BOLT, MACHINE - DOUBLE HEXAGON EXTENDED
WASHER HEAD, CORROSION AND HEAT RESISTANT
STEEL, UNS S66286, 130 KSI MIN, .3750-24 UNJF-3A

AS9559
SHEET 1 OF 3

REV.
B

FIGURE 1 - BOLT

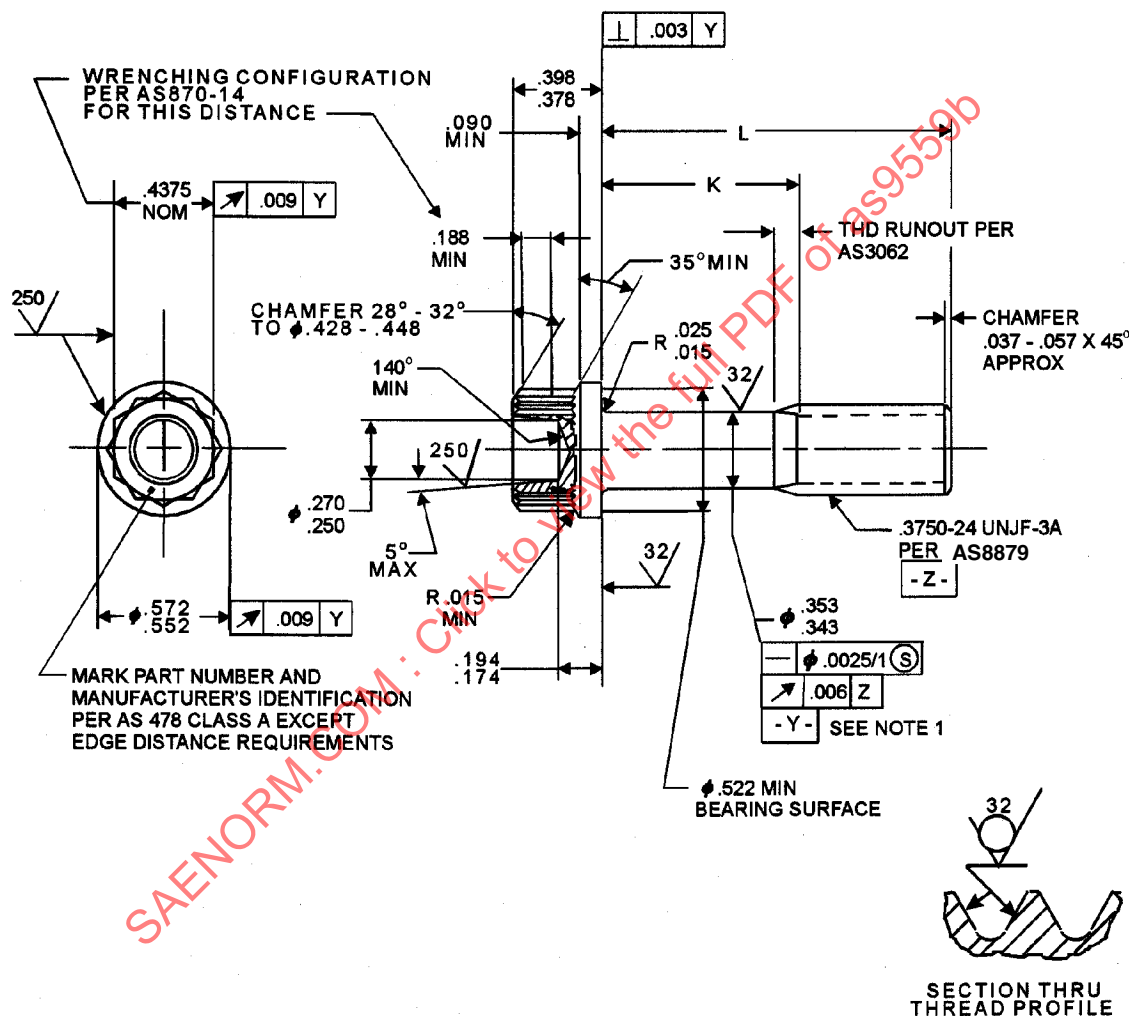
ADD DATUM REQUIREMENTS FOR -03 THRU -18 LENGTHS (NEW NOTE 1) AND REVISE THREAD SPEC TO AS8879.
